FccID: H9PDM4046

Conf Num: EA99556

Correspondence # 18840

Data Phone DS Module

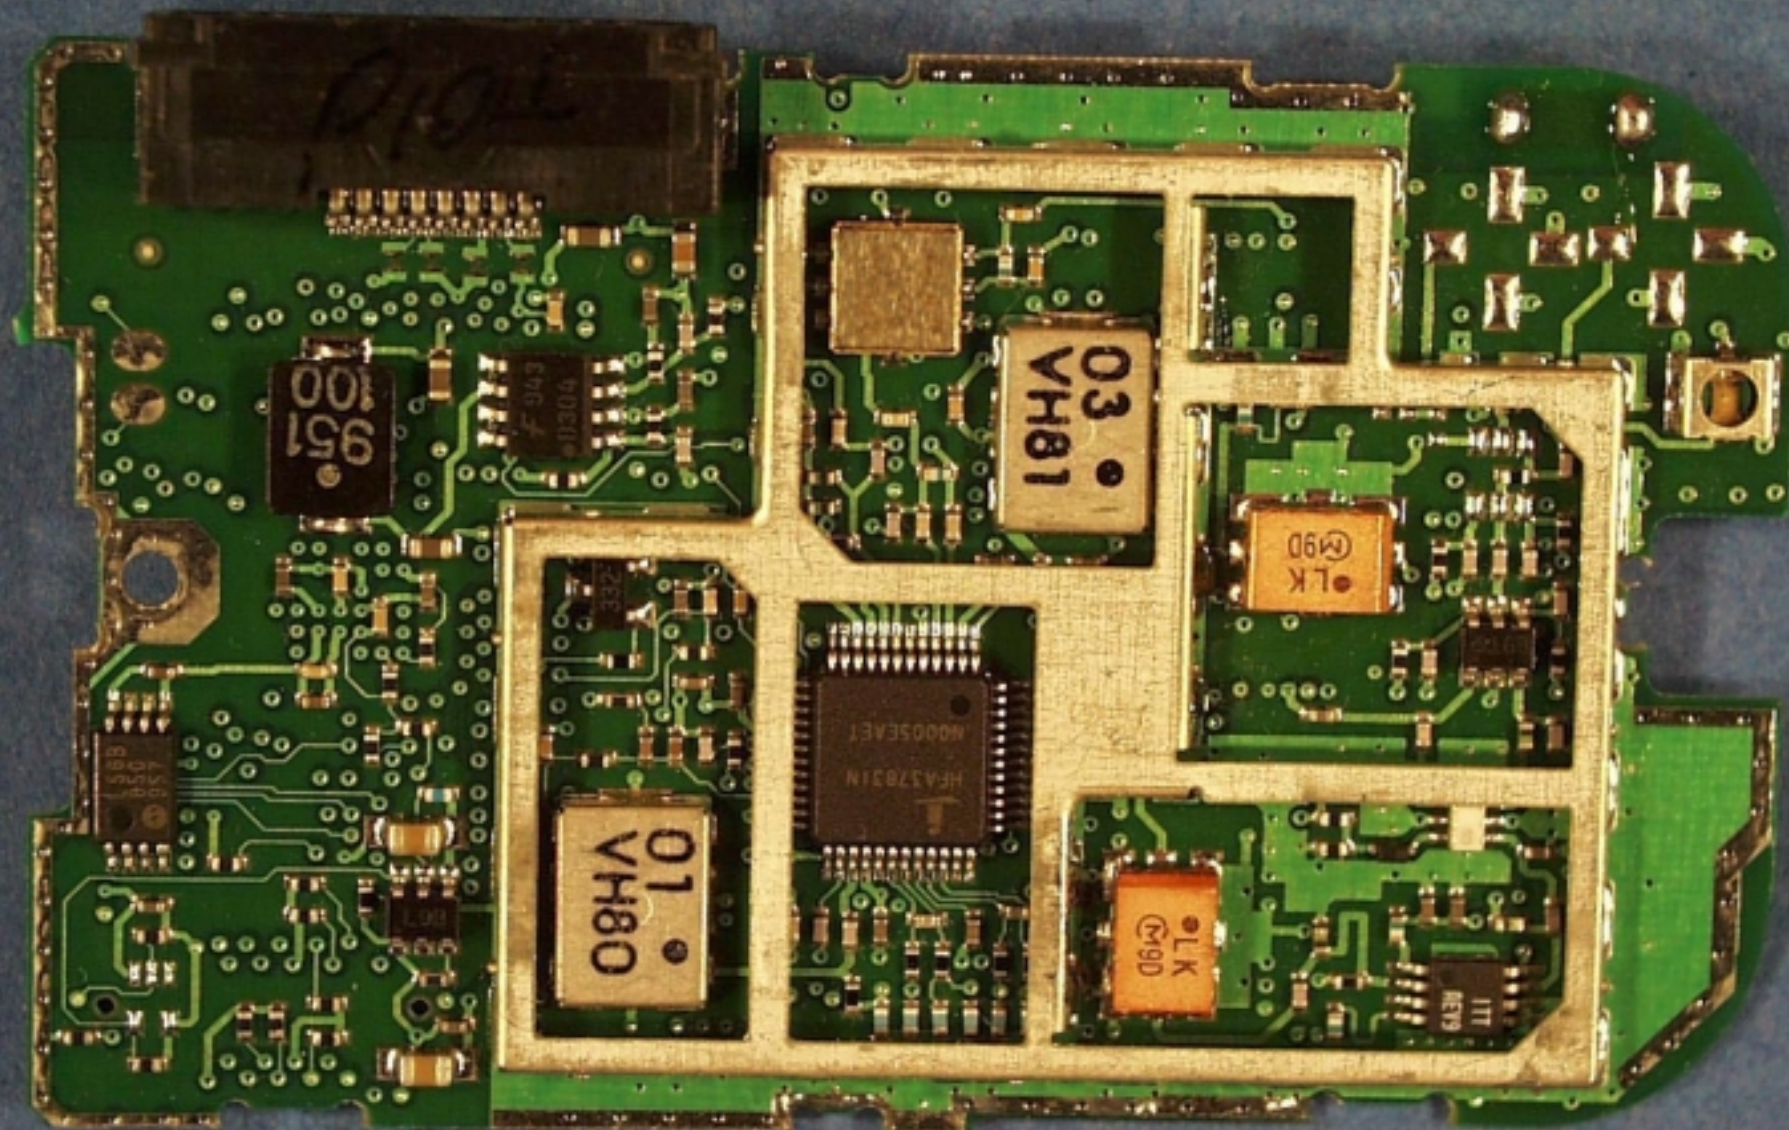
What is the FCC identifier for the LA4021 WLAN card? Confirm that they are the same exact transciever.

The FCC ID is H9PLA4121. They are the same transciever.

1. The transmitters are the same.
2. The receivers are the same.

The only difference between the devices are the outline of the PCB and parts of the digital control sections. Although the outline of the PCB is different the layer stackup and thicknesses are the same. I have included a picture of each transceiver so that you may compare them. The transceivers are within the shield frames.
